FOR "AS CONSTRUCTED PLANS" ONLY

Washington State Department of Transportation

SR 433
LEWIS AND CLARK BRIDGE
DECK REPLACEMENT

PLAN

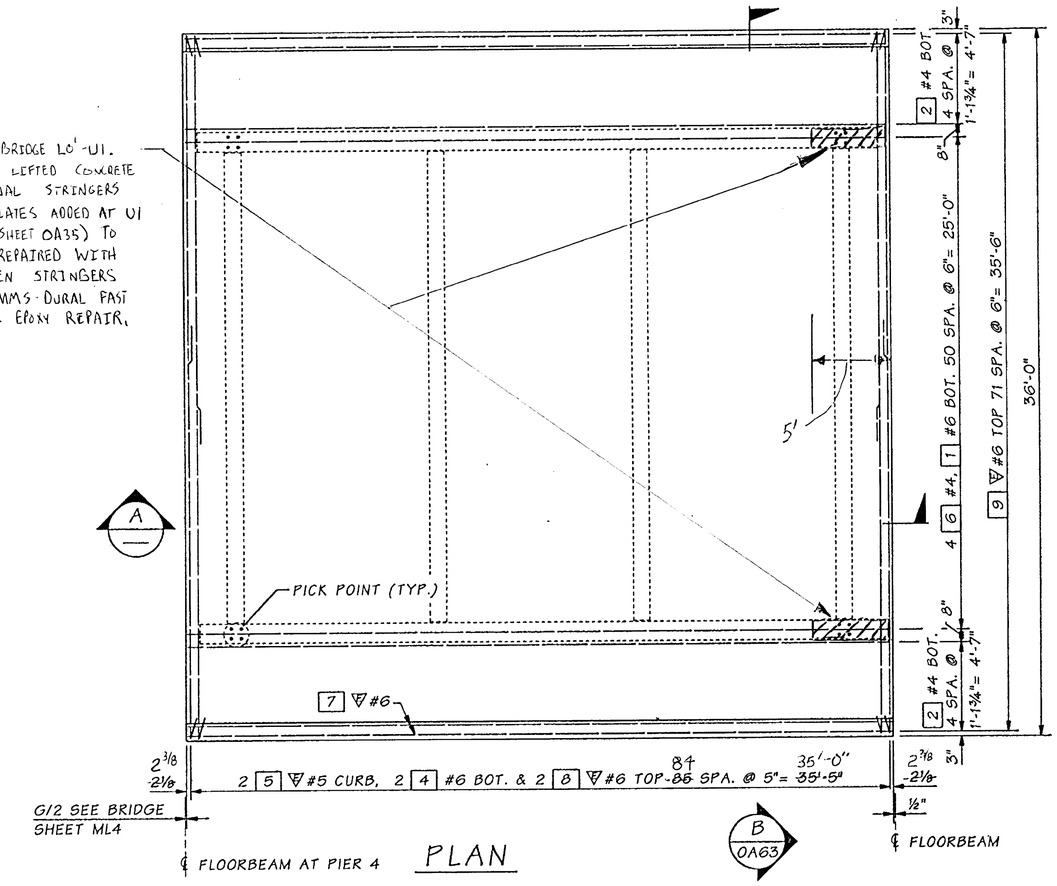
WHEN PANEL INSTALLED AT BRIDGE L0'-U1. U1 SIDE HIT CONFLICT AND LEFTED CONCRETE DECK OFF OF LONGITODINAL STRINGERS FOR APPROX. 5'. SHIM PLATES ADDED AT U1 UNDER SS ROCKER (SEE SHEET OA35) TO RAISE DECK AND PANEL REPAIRED WITH EPOXY INJECTION BETWEEN STRINGERS AND CONCRETE DECK.. TAMMS-DURAL FAST SET EPOXY LV USED FOR EPOXY REPAIR.

MISLOCATED LUMINAIRE SECTION

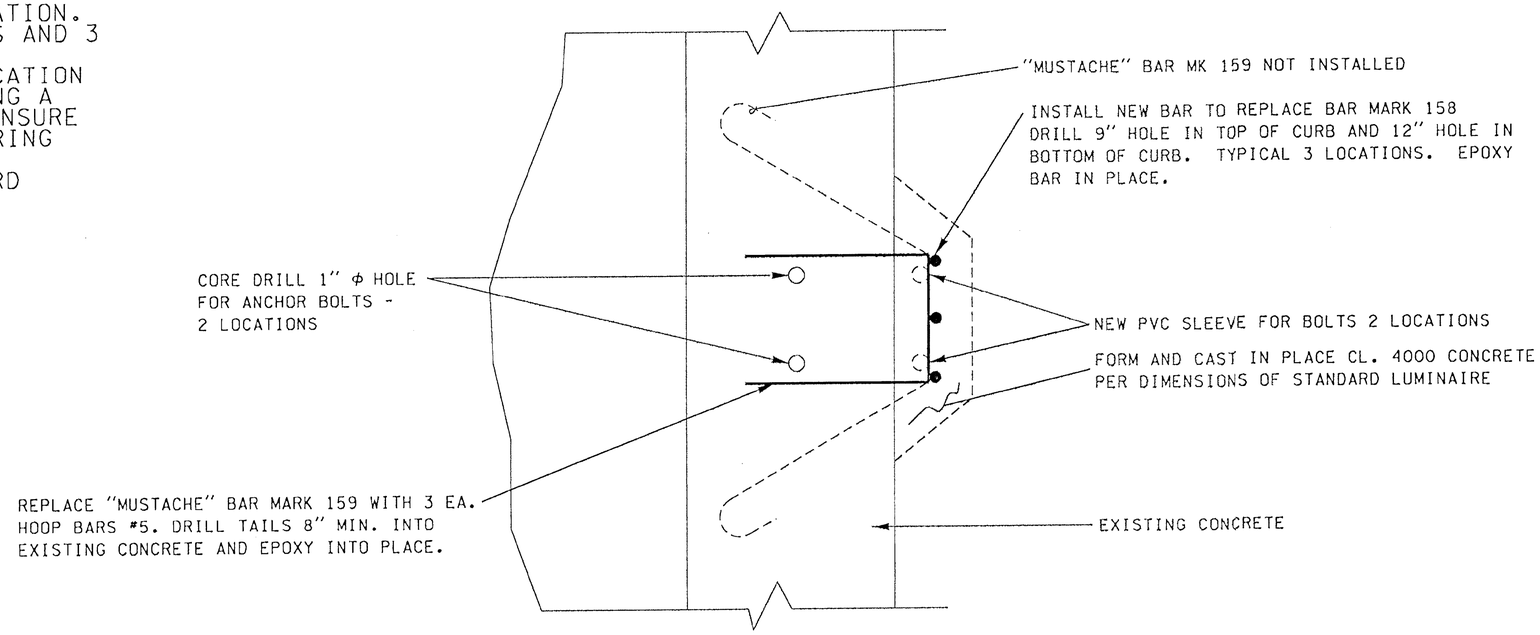
REFERRING TO CONTRACT PLAN SHEETS 216/217 AND 65, THE LOCATION OF THE LUMINAIRE ON 4L EXISTS BETWEEN THE "B3" AND THE FIRST "A" SECTION INSTEAD OF BETWEEN "D" AND "H1" SECTIONS. THE LOCATION OF THE LUMINAIRE ON THE 22L SECTION EXISTS BETWEEN THE "C2" AND THE FIRST "A" SECTION INSTEAD OF BETWEEN THE TWO "D" SECTIONS.

SECTION A

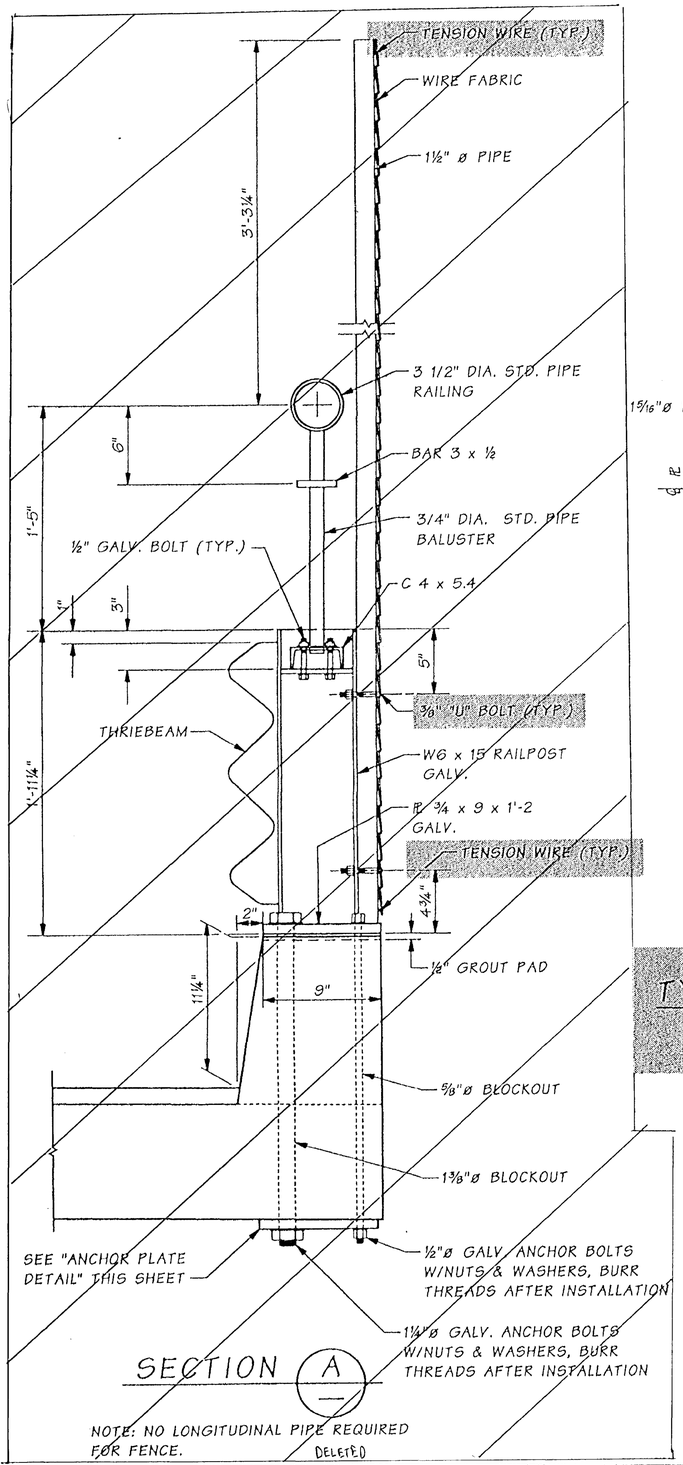
NOTE: NO LONGITUDINAL PIPE REQUIRED FOR FENCE. DELETED

EXPANSION RAIL @ PANEL POINT L27' AND PIER 5

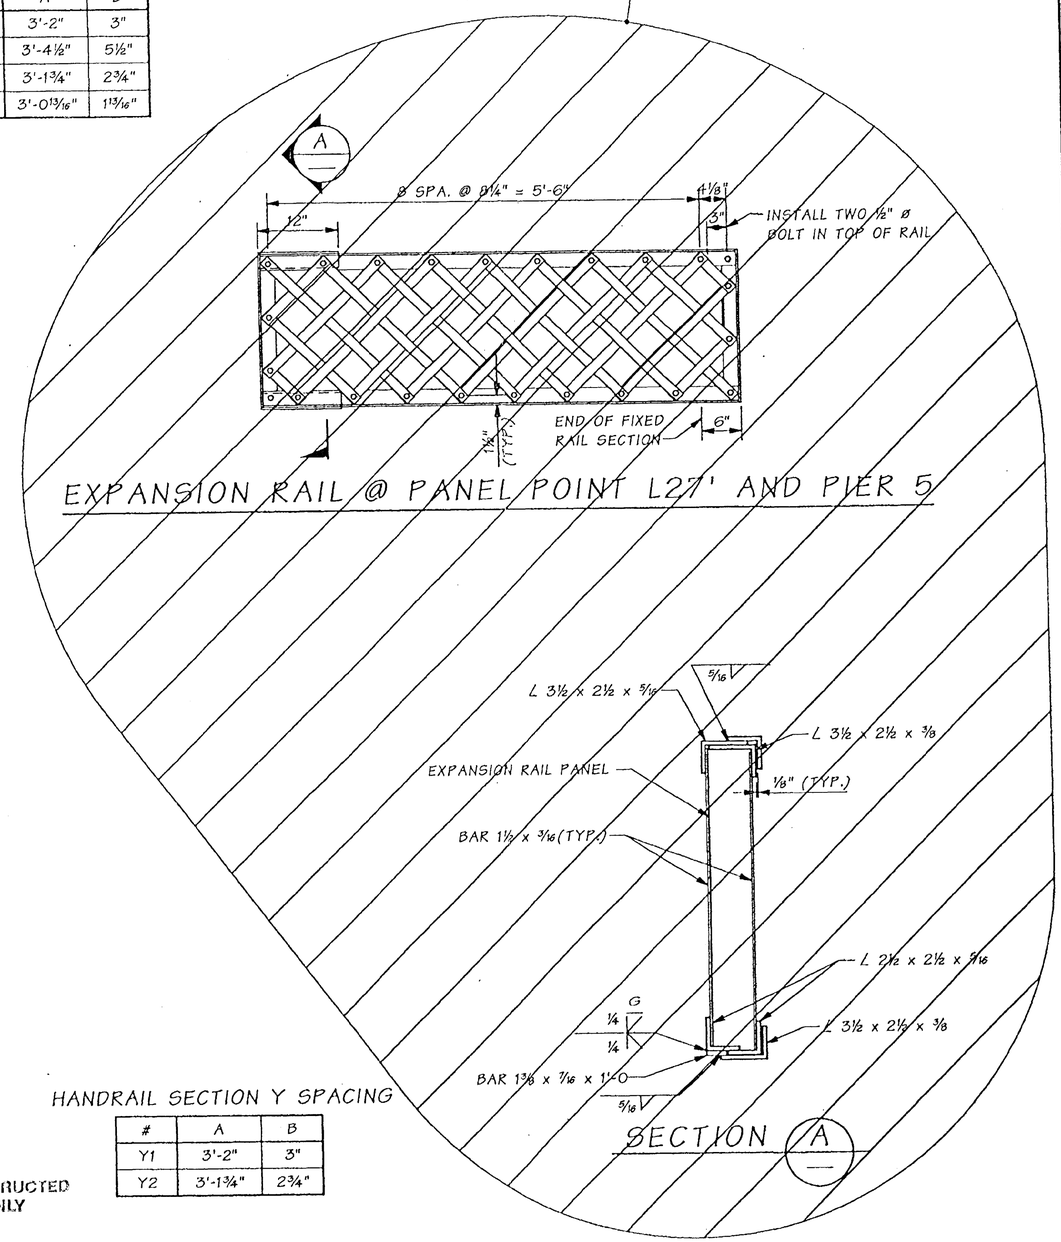
1 EXPANSION RAIL DETAILS ON THIS SHEET ARE DELETED AND REPLACED WITH EXPANSION RAIL DETAILS ON BRIDGE SHEET ML22A.
